Response to Technical Recommendations from the 2008 Review

2009 Annual DOE Progress Review
SC LQCD Computing Project
Fermi National Accelerator Laboratory
June 4-5, 2009

Comparison of results from 2007 and 2008 user surveys, regarding satisfaction with the allocation process.

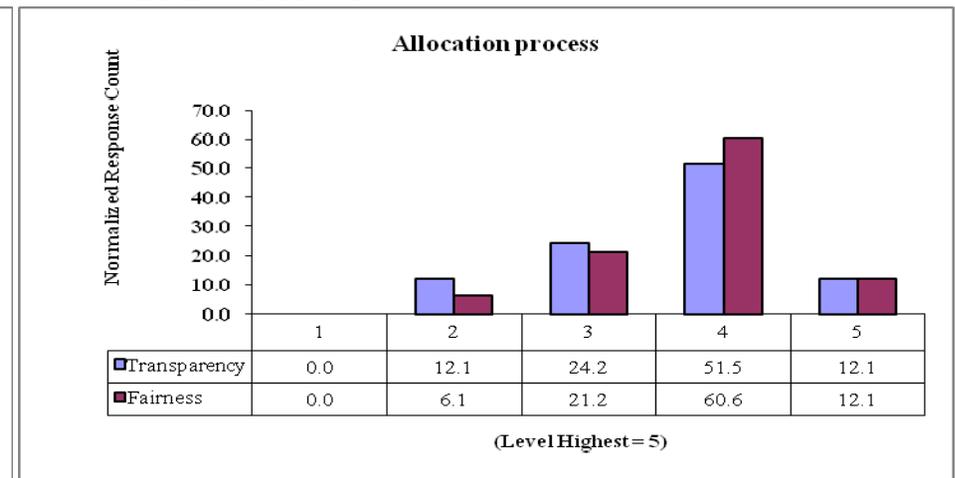
The user surveys indicated that the transparency of the allocation process could be improved. Additional more specific surveying should be pursued by LQCD to pinpoint the source of the problem and to remedy it.

2008 survey results:

Transparency: 10% moved from 5 to 4, and 10% moved from 3 to 2; overall = **xx% vs. xx%** (FY07)

Fairness: 12% moved from 5 to 4 and 9% increased from 3 to 4; overall = **xx% (relatively unchanged?)**
